Re: Impasse Appeal - Response to Inquiries by ALUC Staff

Re: Draft Environmental Impact Report for the Los Angeles International Airport
Specific Plan Amendment Study - Comments of City of Inglewood, City of
Culver City, City of Ontario and County of San Bernardino

Re: Final Environmental Impact Report for the Los Angeles International Airport
Specific Plan Amendment Study - Comments of City of Inglewood, City of
Culver City, City of Ontario and County of San Bernardino

Figure 1a. Example EDMS (B747-400) Emission Rates by Operational Mode

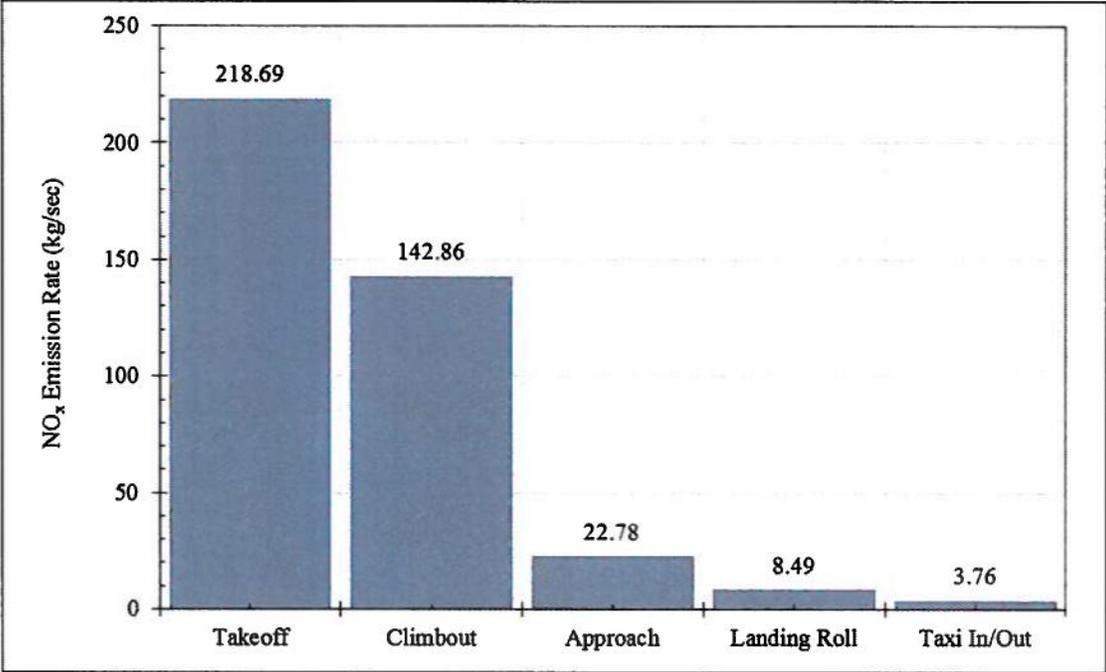
As expected, NO_x emissions are directly related to thrust, being highest during takeoff and declining with thrust through the other modes. The exception is for the landing roll operational mode within which the FAA (through the EDMS User's Manual) claims to include reverse thrust operations. Such operations are high thrust and should reflect a relatively high NO_x emission rate, similar in magnitude to that of takeoff and climbout operations.

For the B747, Figure 1a indicates that landing roll NO_x reflects nothing more than a power-down transition from approach thrust to engine taxi. It might be possible that the reverse thrust portion of the landing roll mode is simply being "averaged down" with non-reverse thrust portions of the same mode. Figure 2a and 3a, however, seem to indicate that this is not the explanation.

Figure 1b. Example EDMS (B737-800) Emission Rates by Operational Mode

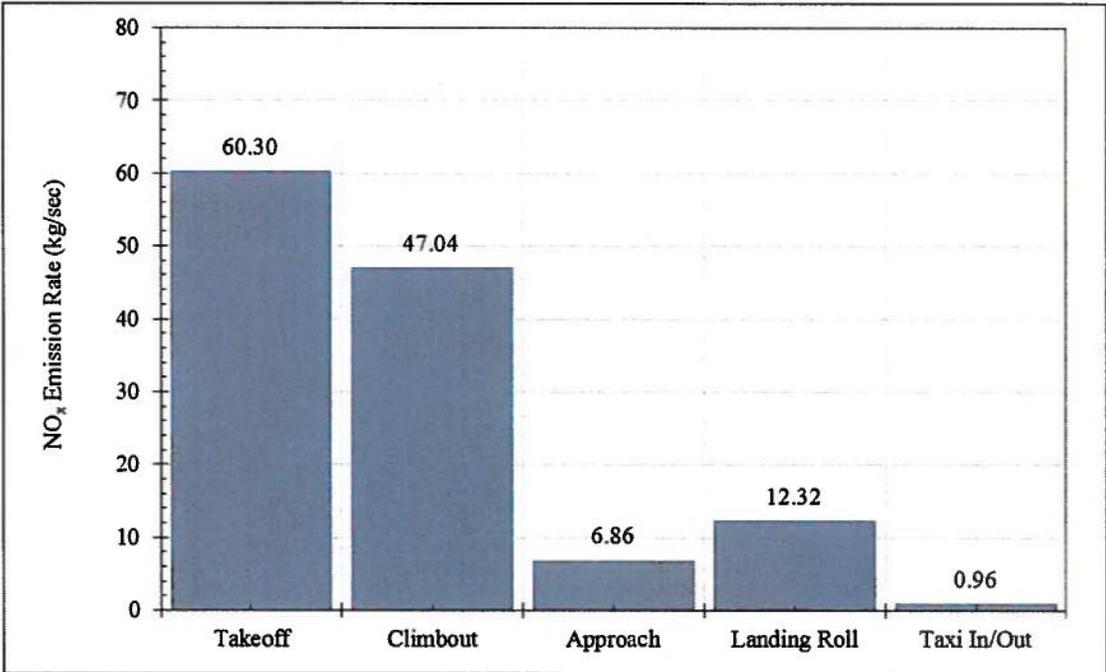
The results are somewhat different for the B737. Figure 1b demonstrates a minor increase in landing roll NO_x from approach thrust, but this increase is far lower than the high thrust operations that would normally be expected from reverse thrust.

Figure 2a. Example EDMS (B747-400) Operational Mode Durations

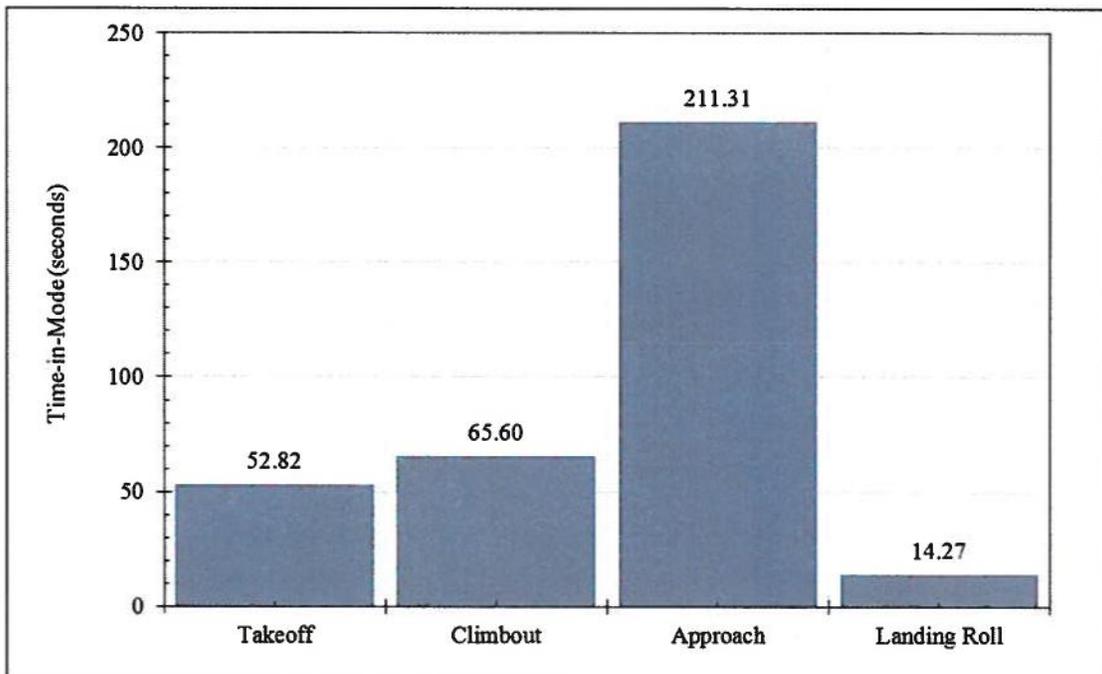
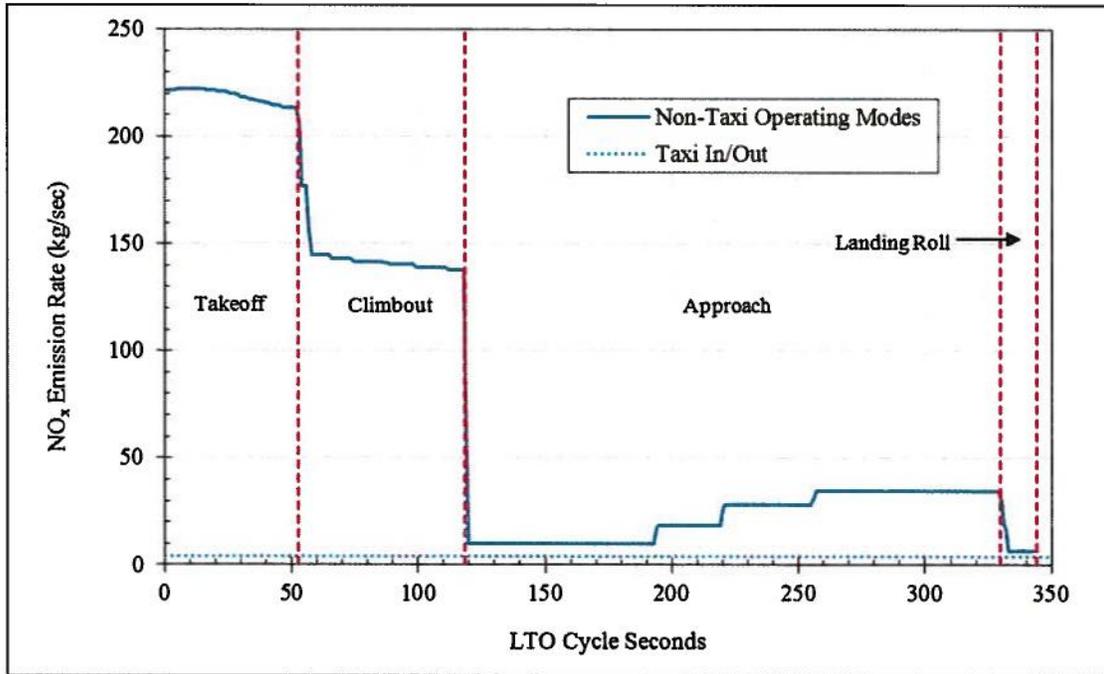
Figure 2a demonstrates that the duration of the entire landing roll operational mode is less than 15 seconds. The reverse thrust operation alone would generally endure for that entire period. Moreover, in Figure 3a, which depicts the second-by-second data for the aircraft operating modes, the transition from approach to landing roll operations clearly reflects the absence of any NO_x spike of any duration associated with the B747 landing roll.

Figure 2b. Example EDMS (B737-800) Operational Mode Durations

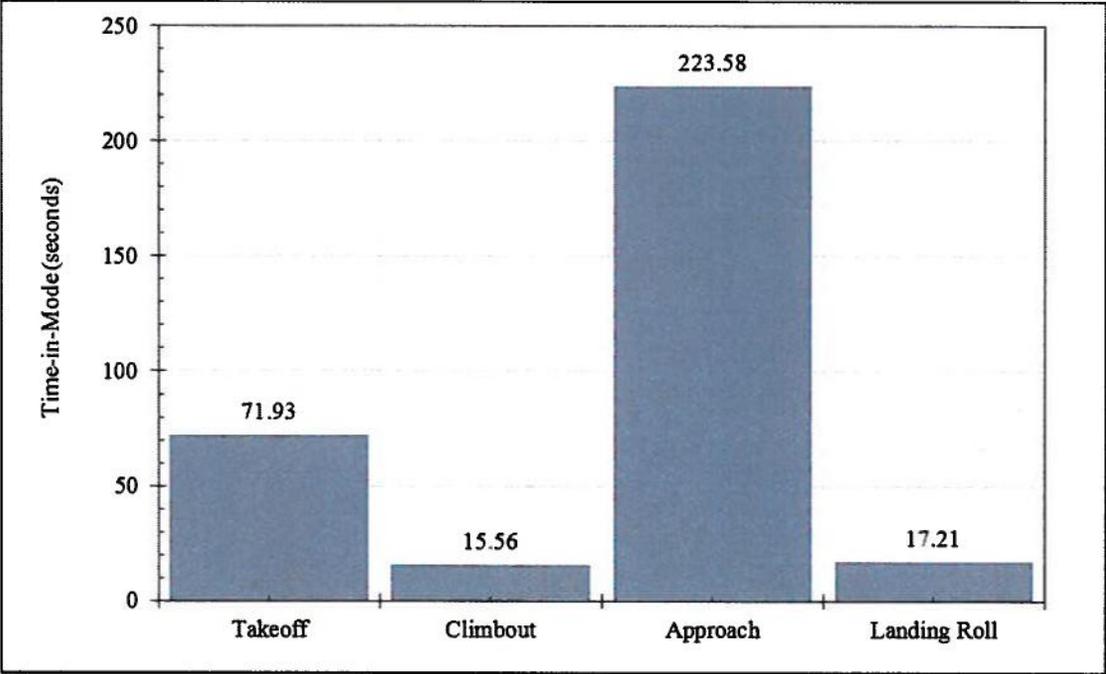
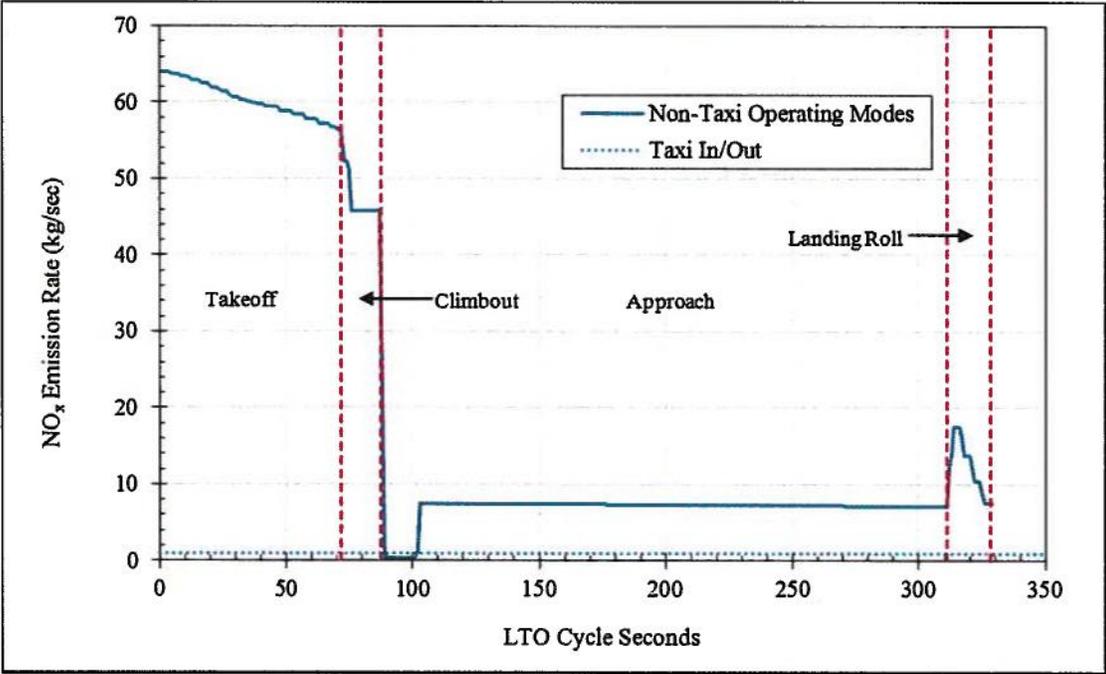
Figures 2b and 3b show that, as was the case for the B747 example, the “muted” effect does not result from any landing roll averaging. In fact, the thrust increase is fairly constant across the complete 17 second landing roll, as depicted in Figure 4b.

Figure 4a. Example EDMS (B747-400) Relative Thrust (as NO_x) by Mode

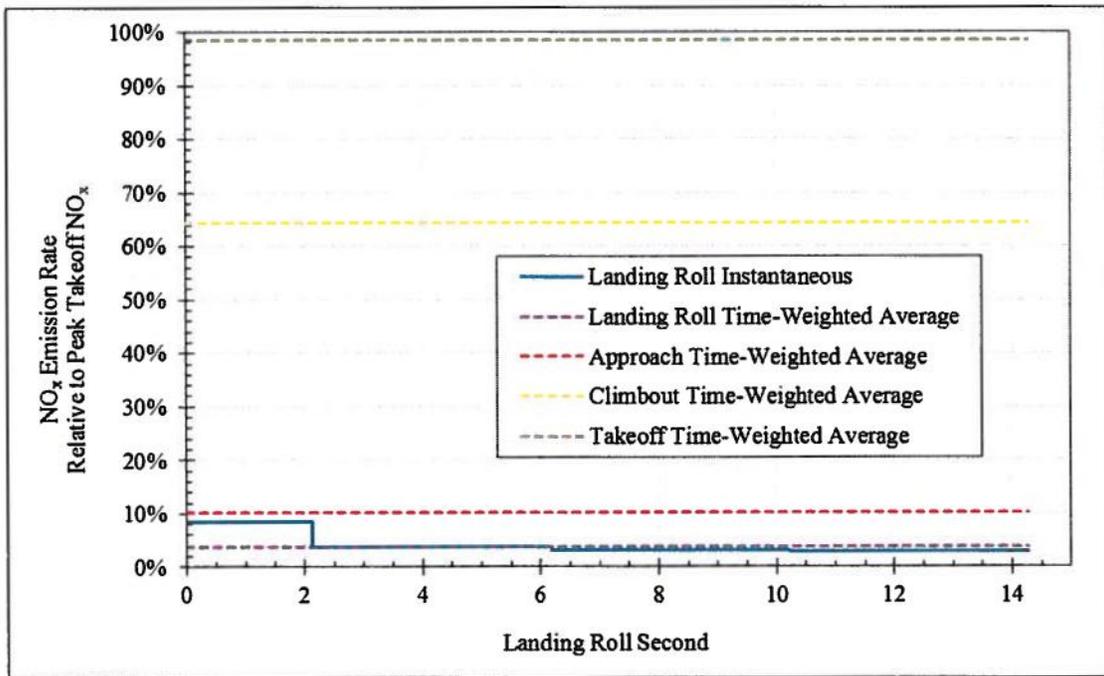
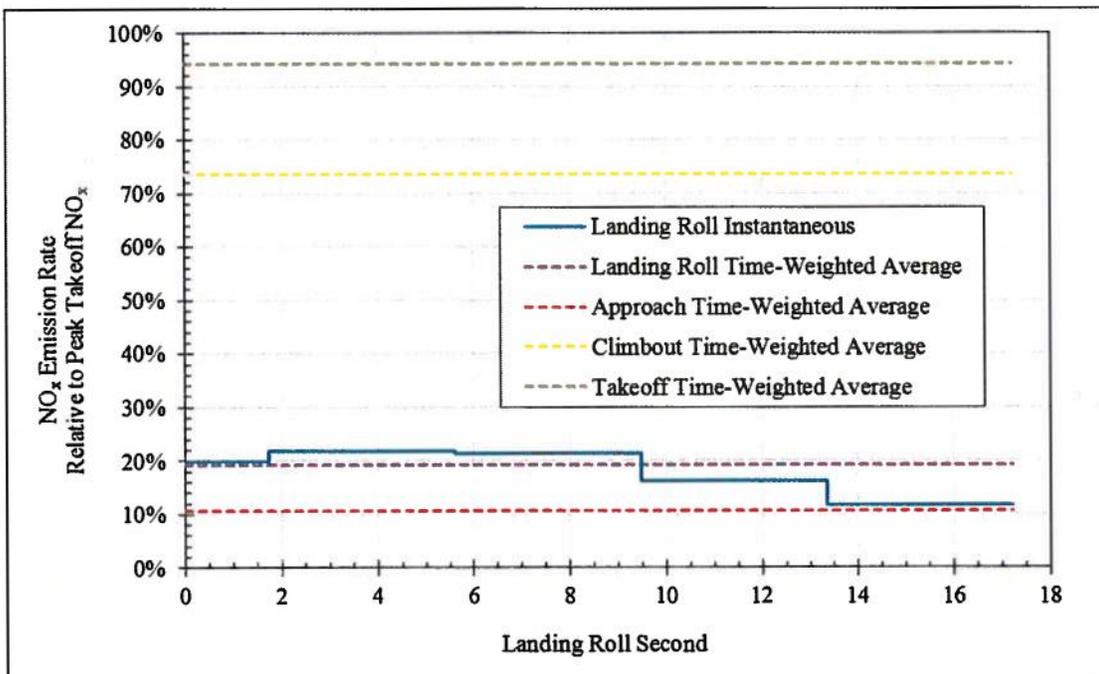
Figures 4a and 4b summarize the example results in terms of relative NO_x emissions rates across the four non-taxi operating modes. For these figures, mode specific NO_x is compared to peak takeoff NO_x on the premise that NO_x emissions rates are a reasonable surrogate for engine thrust conditions. As expected, takeoff and climbout thrusts are significant fractions of peak takeoff thrust. For the B747, Figure 4a demonstrates no reverse thrust operation during the landing roll. For the B737, Figure 4b, landing roll thrust is increased as would be expected during reverse thrust operations, but by a relatively modest amount.

From these calculations, it does not appear that EDMS properly accounts for reverse thrust operations. Accomplishing that task requires more than a User's Manual statement. Only a full review of the model algorithms and data sets would allow for any definitive determination of the EIR's analytic integrity. From the examples set forth above, it can be definitively stated that, if EDMS is modeling reverse thrust, the associated emissions are far lower than would be expected under FAA's guidelines for such modeling. As stated in FAA's "*Air Quality Procedures for Civilian Airports and Air Force Bases*," Appendix D, p. D-5, "[r]everse thrust is now considered by EPA as an official mode and should be included in calculation procedures as a sixth operating mode when applicable. Since reverse thrust engine operating conditions are similar to takeoff, time spent in reverse thrust should be combined with takeoff mode emissions indices and fuel flow as a means of accounting for reverse thrust mode emissions. Aircraft reverse thrust typically is applied for 15-20 seconds on landing." That these rules are not reflected in the EIR analysis calls into question the integrity of the EIR emissions calculations.
